SUBJECT: Invitation for Bid #10-1744-OV
Dude Ranch Acres Sanitary Sewer Improvements
Project No. 6073980

ADDENDUM #1

ADDENDUM No. 1

IRRIGATION LINE SKETCH

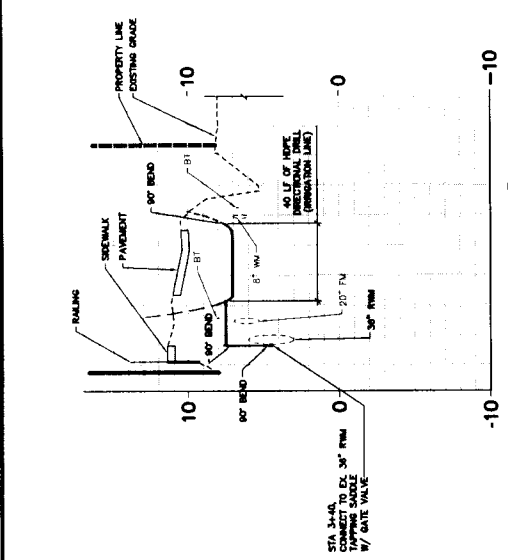
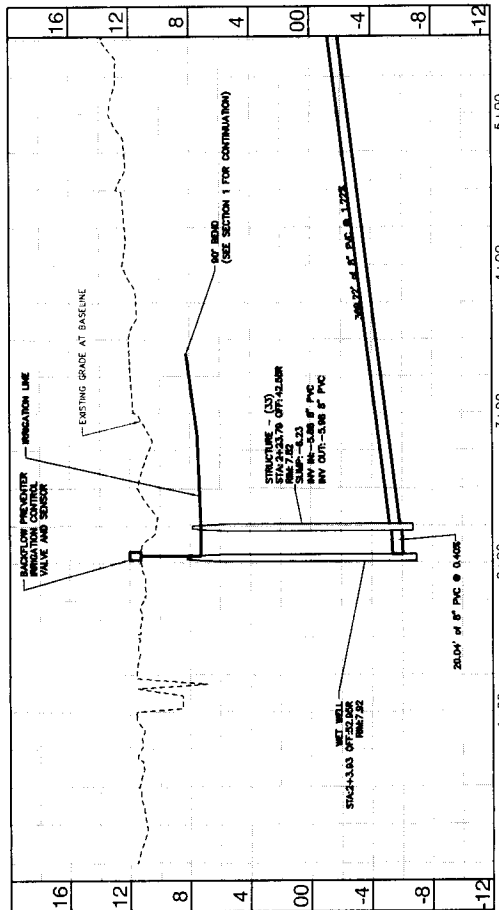
Question: There is nothing on the plans showing how we are to bring "Non-Potable Water" to the site for purposes of irrigation. The plans do show an existing 36-inch reclaimed water main at the west side of Caruso Road but, it appears at that location the pipeline was installed by directional drill and could very well be HDPE and could be very deep. The drawings do not show the elevation of the existing utilities in profile view. Please confirm depth of this pipe and how we are to bring irrigation service to the site. Consideration should be given to whether or not the 36-inch reclaimed water main pipe is actively under pressure and operating at full capacity.

Response: Refer to attached sketch. A new irrigation line shall tap into existing 36-inch reclaimed water main at approximately station 3+40, using the stationing given on the Contract Drawings, where depth of the main decreases to approximately 10 feet. New irrigation piping must be run beneath Caruso Road by HDD. The size of new irrigation piping will be dependent on landscape and irrigation plans submitted. Payment for HDD for the reclaimed irrigation line shall be made under Pay Item 10B. Payment for other irrigation related items shall be made under Pay Item No. 7.
